Planning Commission

TO: Planning Commissioners
FROM: Katie Peterson, AICP, Senior Planner
RE: Review of Revised Plans to COFA-03-23-017836
DATE: 10/25/2023
CC: Kevin Icard, AICP, Director of Growth Management

RE: Big Blue Marble Cypress Ridge – Planning Commission Comment Responses

AirHandler Wiring

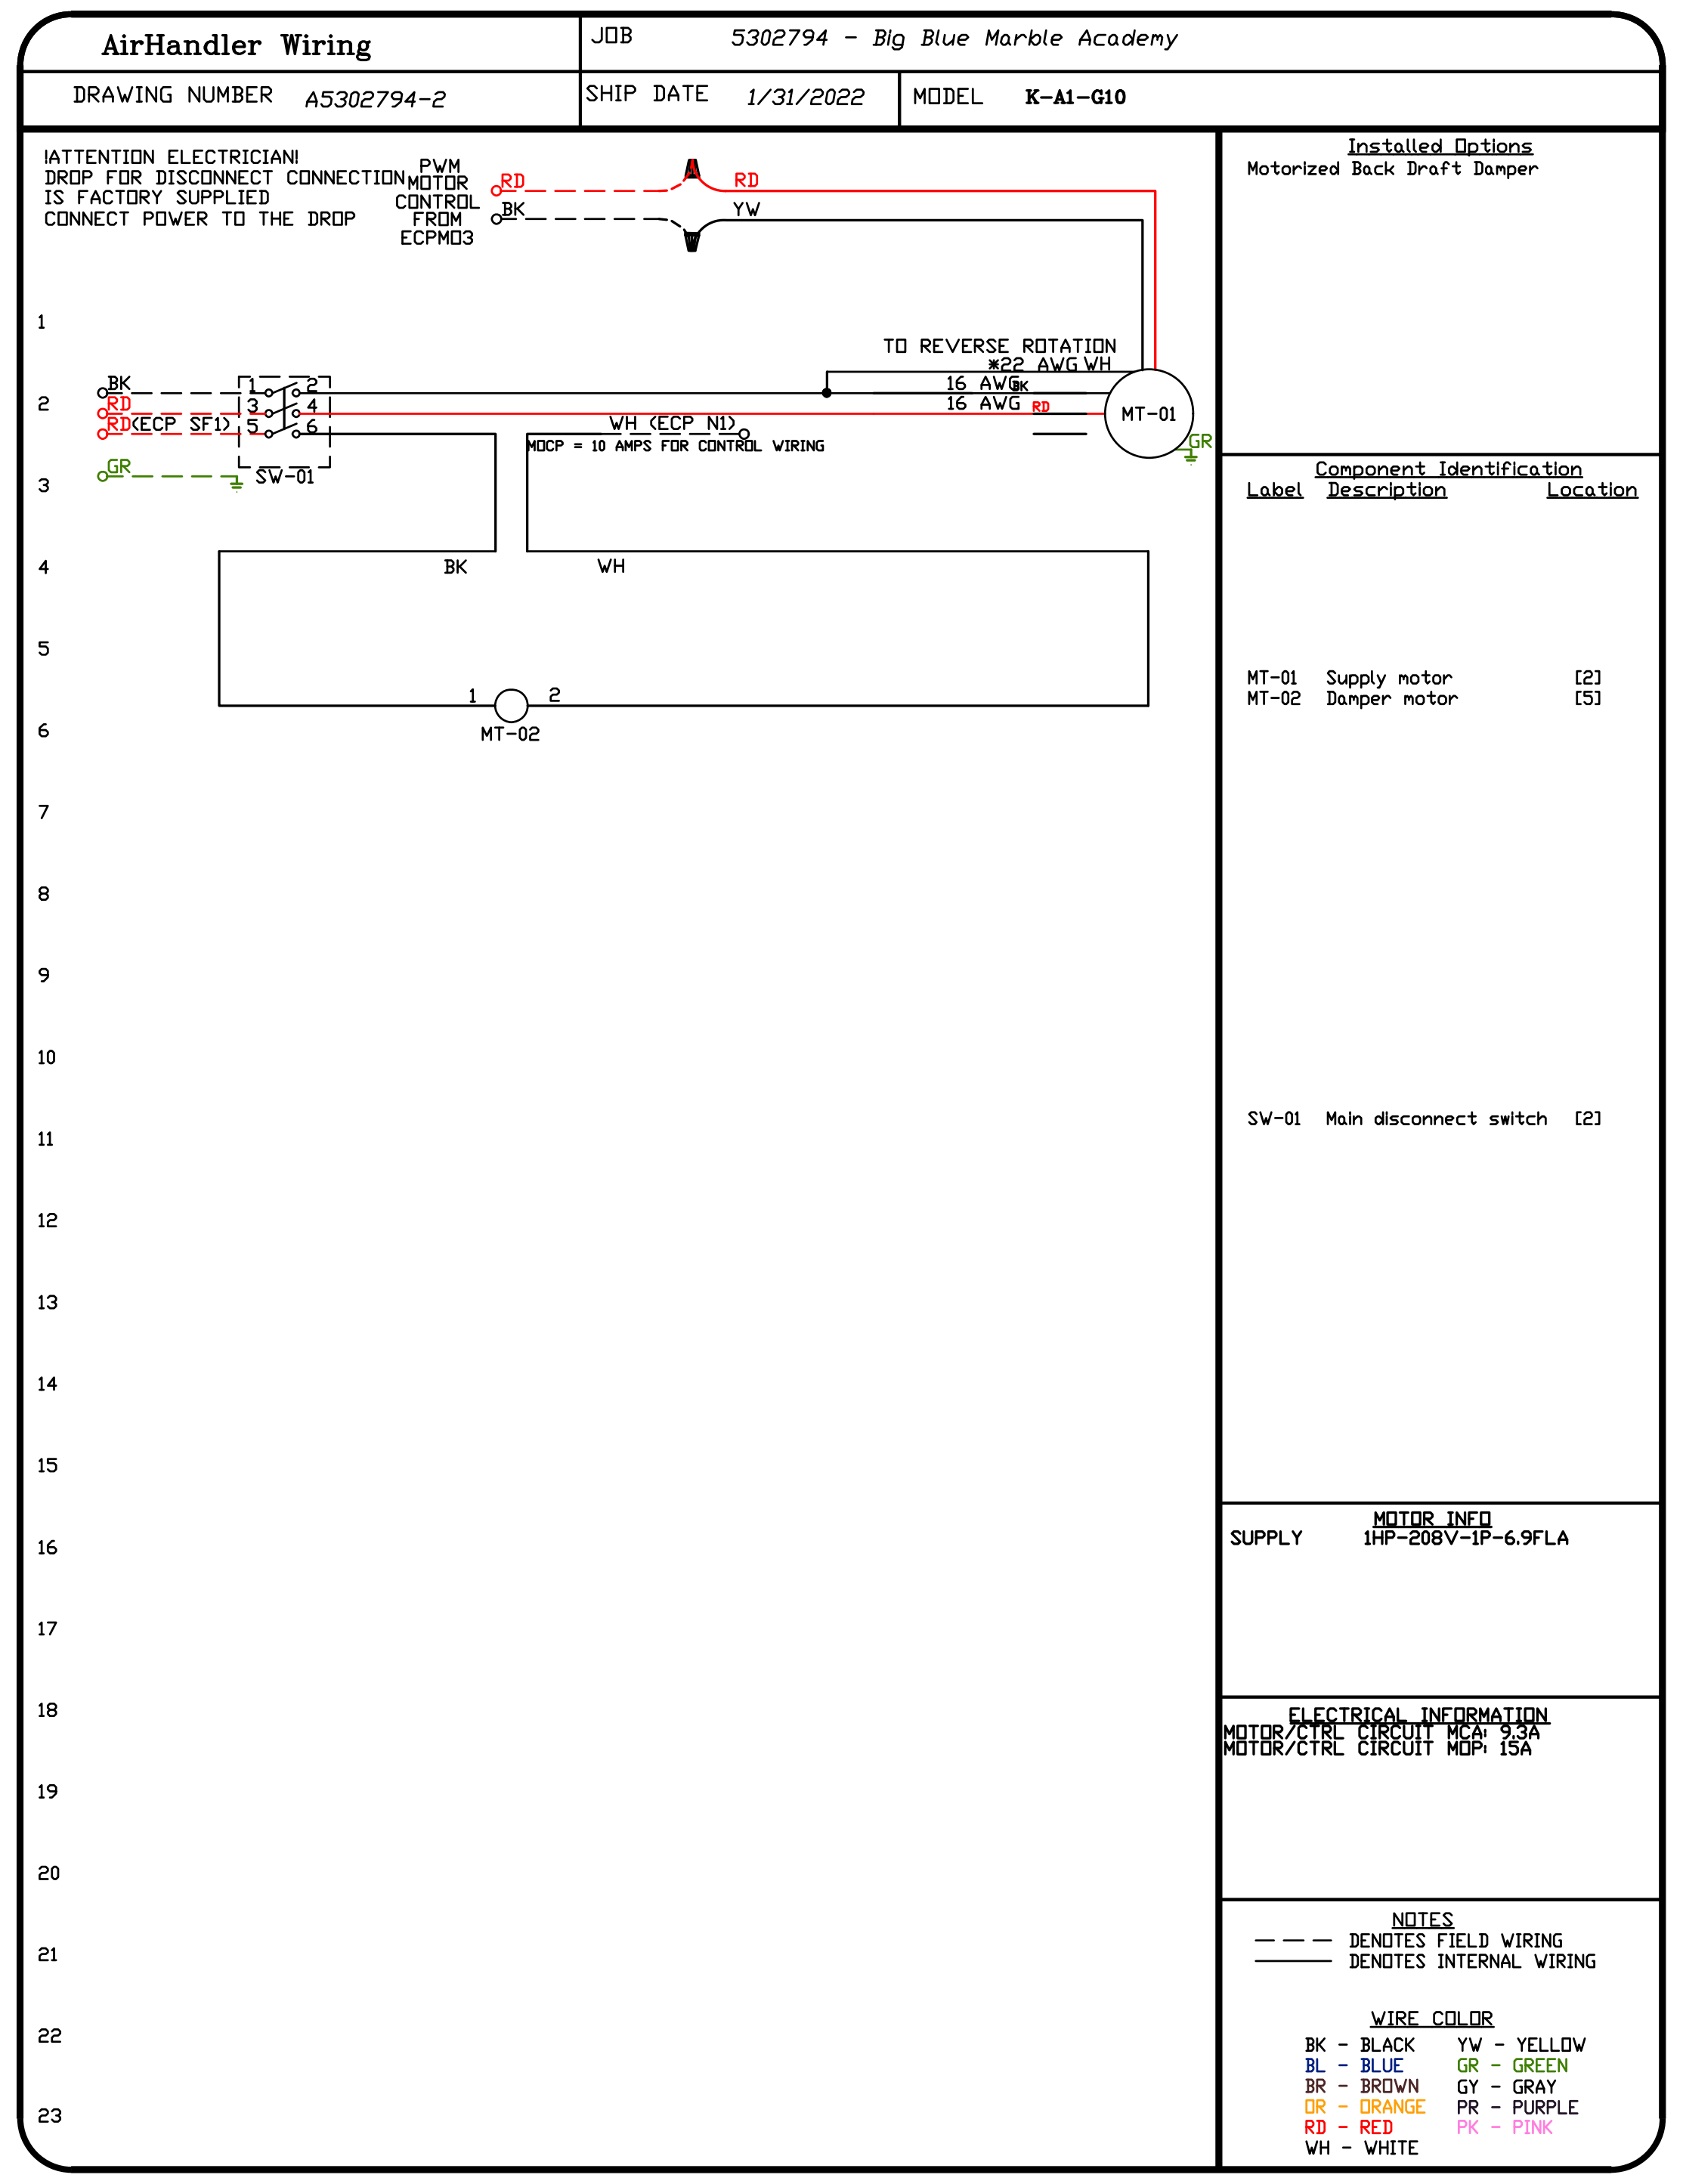
1. Per Section 4.16.2.A. all roof mechanicals are shown on the front elevation, facing Highway 170, and must be revised. While the hood system was shown as screened on the front elevation, building code requires the exhaust to be no less than 10 feet horizontally from parts of the same building, and the intake, if vented at an angle away from the wall(s). It could be 5 feet of clearance from the wall(s) if angled away, but still requires 10 feet of clearance from the intake. It was not able to be met in the space provided and needed to be redesigned.

1. **Architecture**
   a. Per Section 4.16.2.A. all roof mechanicals are shown on the front elevation, facing Highway 170, and must be revised.
      - The kitchen exhaust vent has been rerouted to outlet out the sidewell of the building, on the east elevation.
      - The rooftop mechanical unit has been inset into the roof line to provide screening from Highway 170. The specification sheet for the make-up air unit has been provided with this resubmittal.
